SUNDRY NOTICES AND REPORTS ON WELLS
Do not use this form for proposals to drill or to re-enter an abandoned well. Use form 3160-3 (APD) for such proposals.

#2, sec 26, T28N, R1W, API# 3003907247

Lease Jicarilla
Well # 2

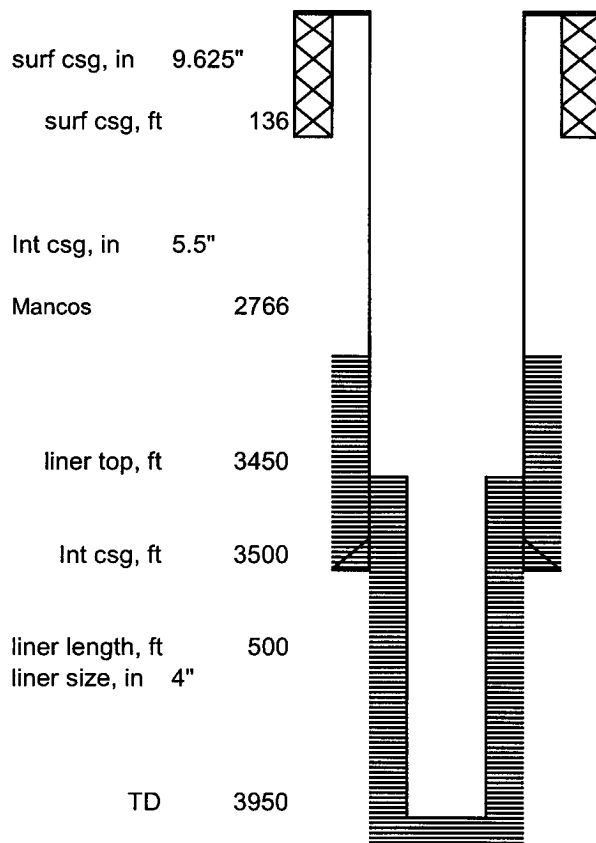
1. Plugging operations authorized are subject to the "General Requirements for Permanent Abandonment of Wells on Federal and Indian Leases."
2. For wells on Indian leases, Bryce Hammond with the Jicarilla Nation Tribal Oil and Gas Office is to be notified at least 24 hours (48 hours if possible) before the plugging operations commence. His phone number is (505) 759-1823, x-31 office, (505) 320-9741 cell. Office hours are 7:45 a.m. to 4:30 p.m.
3. Blowout prevention equipment is required.
4. The sundry is approved with the following change:
Plug 1 – CR @ 3425, 42 sacks below, 10 sxs above – okay

Plug 2 – CR @ 2716, Perforations at 2766, 165 sxs below, 65 sxs above – need to cover Cliff House Formation

Plug 3 – Perforate at 186, 82 sxs to surface inside and out.
